Docket Number:	06-AFC-07C
Project Title:	Humboldt Bay Generating Station - Compliance
TN #:	211459
Document Title:	Humboldt Bay Generating Station - Petition for Project Modification
Description:	Modification of Fiber Optic Communications System, Relocation of Network Communications System, Installation of New Microwave Dish and Monopole, and Re-Routing of Existing Water Line Segment
Filer:	Jonathan Fong
Organization:	Pacific Gas and Electric Company
Submitter Role:	Public
Submission Date:	5/13/2016 10:28:04 AM
Docketed Date:	5/13/2016

HBGS-CEC-124

Subject: Humboldt Bay Generating Station - Petition for Project Modification (06-AFC-07C),
Modification of Fiber Optic Communications System, Relocation of Network Communications System,
Installation of New Microwave Dish and Monopole, and Re-Routing of Existing Water Line Segment

Petition for Project Modifications – Modification of Fiber Optic Communications System, Relocation of Network Communications System, Installation of New Microwave Dish and Monopole, and Re-Routing of Existing Water Line Segment

FIGURE 1
Proposed New Fiber Optic Line
PG&E Humboldt Bay Generating Station
Eureka, California

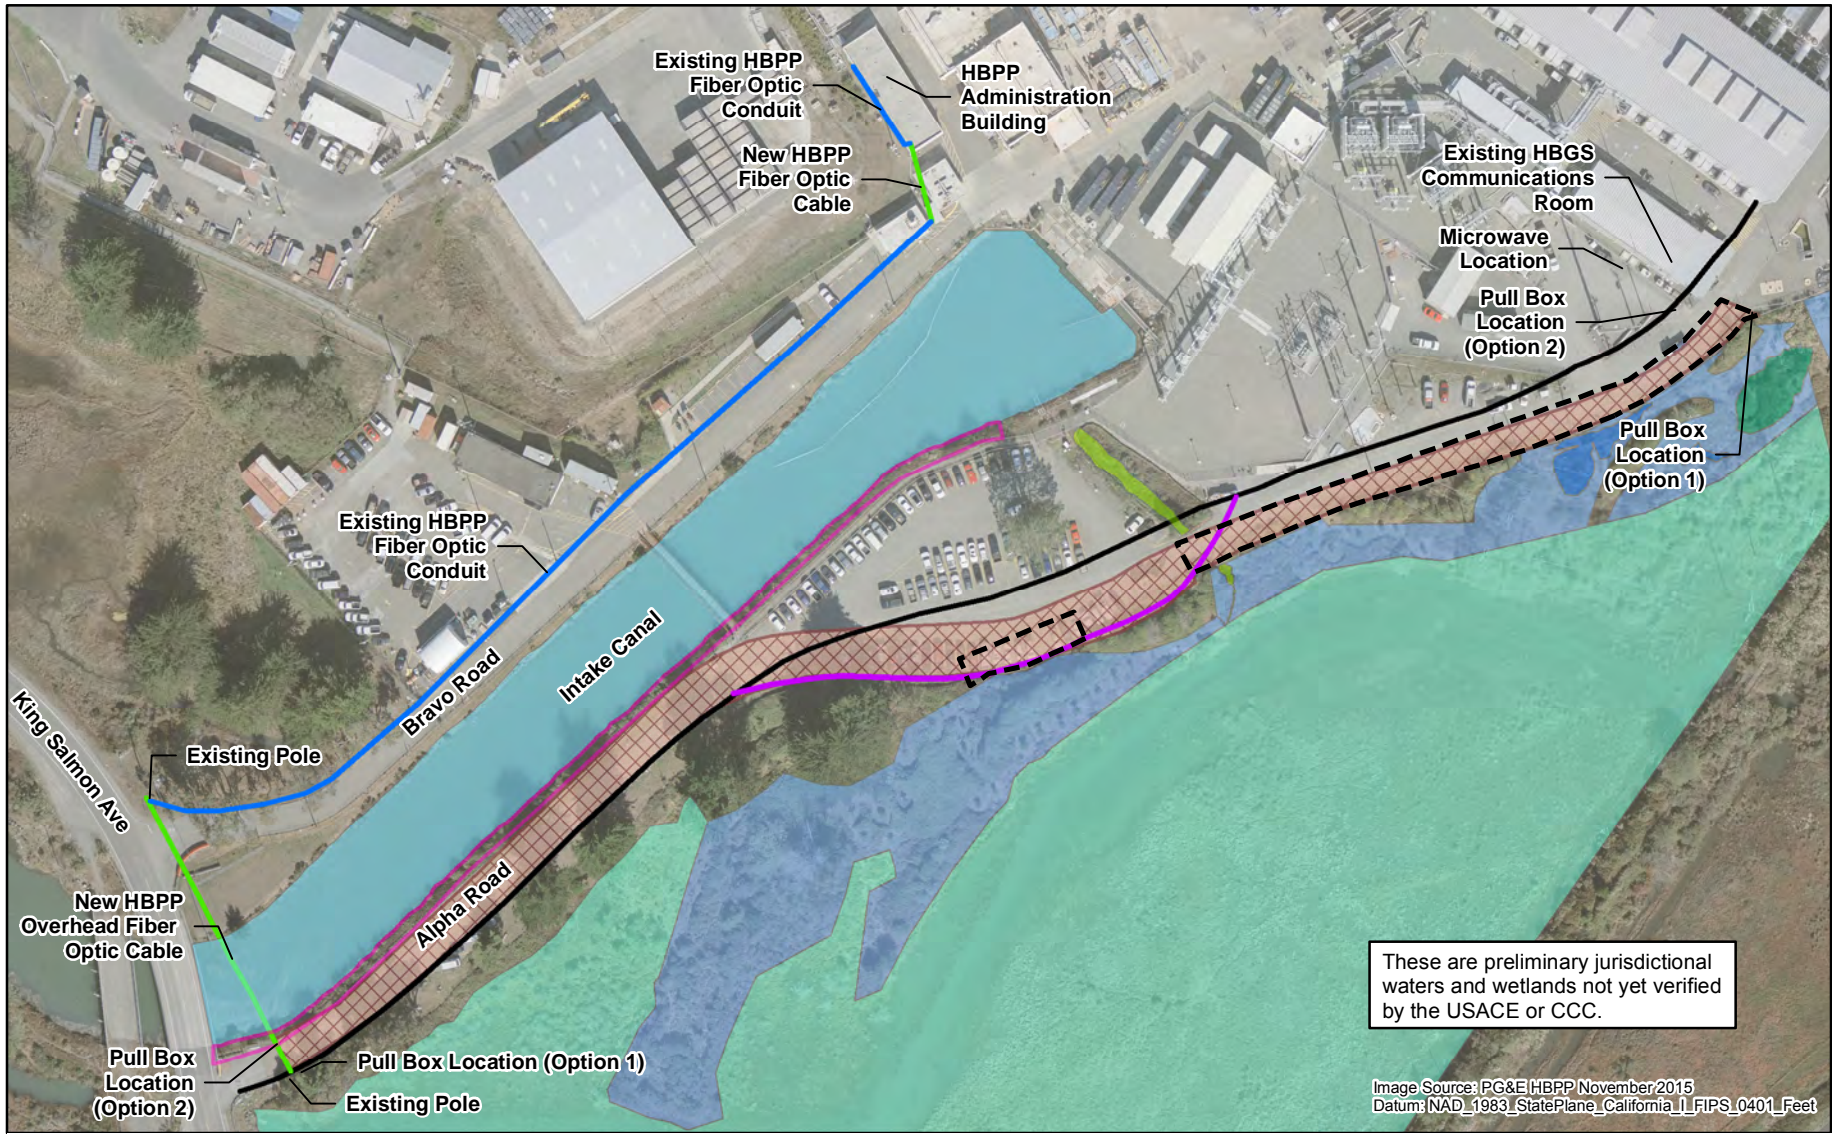
PG&E is seeking approval to install a new fiber optic communications system for HBGS which will interconnect with the existing aboveground fiber optic cable at King Salmon Avenue and extend underground within the Alpha Road corridor as depicted in Figure 1 (see cross-hatched area). Alpha Road serves as the access road for HBPP decommissioning and HBGS and was built to accommodate HBGS heavy loads (transformers and engines) during construction. The approximately 26-foot wide corridor includes the Alpha Road subgrade heavy haul structural road plus approximately three feet on each side. The cables and conduits would primarily be located on the road edge within the corridor. However, the route could cross from one side of the road to the other. The specific route would be determined prior to construction.

The proposed fiber optic cable/conduit corridor extends from the HBGS communications room approximately 1,400 feet along Alpha Road to King Salmon Avenue. A pull box approximately 3 feet wide by 5 feet long by 3 feet deep will be installed at the beginning of the corridor near the HBGS communications room. PG&E is requesting approval of two options for the pull box location (see Figure 1). The final choice among these alternatives will be determined prior to construction. One of the alternative locations near the HBGS communications room is located outside of the wetlands (Option 1). The other is in a developed (paved) area near the HBGS administration building (Option 2).

On the east side of the fiber optic corridor, there are Coastal Commission and U.S. Army Corps of Engineers (USACE)-jurisdictional wetlands (see Figure 1). If the cables, conduits and pull box are located in the areas near the wetlands, the wetlands will be avoided and a biological monitor on-site during construction in these areas. The wetlands will also be protected with flagging or fencing to preclude equipment and personnel from entering the area. Some of the wetlands are located outside of the HBGS fence line. No construction will occur outside of the HBGS fenced boundary.

At King Salmon Avenue, the fiber optic cables will interconnect with an existing utility pole located on the east side of the corridor at the intersection of King Salmon Avenue and Alpha Road. A pull box will be installed at one of two locations near the utility pole at King Salmon Avenue (see Figure 1). The fiber optic cables will transition aboveground to the existing pole, and the HBGS cable will interconnect with an existing AT&T overhead fiber optic cable on the utility pole. Both the existing pole and the two pull box locations are situated in previously disturbed, non-native vegetation comprised primarily of annual grasses that are regularly mowed.

At the existing utility pole the fiber optic cable supporting HBPP will continue overhead (with several other existing overhead lines) heading north-northwest, paralleling King Salmon Avenue, until it reaches an existing utility pole near the west end of Bravo Road (see Figure 1). At this point it is anticipated that the cable will transition underground through existing conduit. The new fiber optic cable will then be pulled through the existing conduit located along Bravo Road for approximately 725 feet in a northeasterly direction to a point near the existing security checkpoint. The route will then likely head north where an approximately 70-foot-long segment of new conduit will be installed within a concrete and paved area. The new conduit will then interconnect with existing conduit which runs adjacent to the western side of the HBPP Administration Building. Here, the fiber optic cable will interconnect with HBPP communications equipment that will be located in the building to support decommissioning and restoration, and the ISFSI.

A new microwave dish and monopole will be installed in a graveled area approximately 15 feet from the HBGS Administration Building, as shown on Figure 1. The new microwave dish will provide communications system redundancy and serve as a backup to the fiber optic communications system. The microwave dish will be 10 feet in diameter, mounted on a new 40-foot-tall monopole. The centerline of the microwave dish will be at the 30-foot height of the pole. Two 5-foot-long Omni antennas, currently located on the south side of the HBGS Administration Building, will be removed and mounted on top of the monopole. These antennas are for two-way radios used by HBGS and HBPP personnel. The foundation for the monopole and dish will cover an area approximately 10 feet by 10 feet on the surface and be approximately 10 feet deep. Given the depth of the foundation, it is possible that groundwater will be encountered during the excavation work. Any groundwater will be disposed of using appropriate Best Management Practices in accordance with the HBGS Industrial General Permit, which allows for authorized non-stormwater discharge of uncontaminated water. Installation of the new microwave dish and monopole will not require changes to any Conditions of Certification.

The new water line segment would be located on the east edge of the Alpha Road subgrade heavy-haul structural road, as shown in Figure 1. Vegetation adjacent to Alpha Road on the east side is comprised primarily of non-native annual grasses that are regularly mowed. The new water line segment would be installed in a trench approximately 2 feet wide with a maximum depth of approximately 5 feet. The construction equipment would be limited to Alpha Road. Approximately 6 workers would be required for the one-month-long construction effort. The water line construction would require the use of a backhoe, excavator, and two trucks to remove the spoils. Section 5 provides the environmental protection measures that would be taken during construction if the water line is to be re-routed.
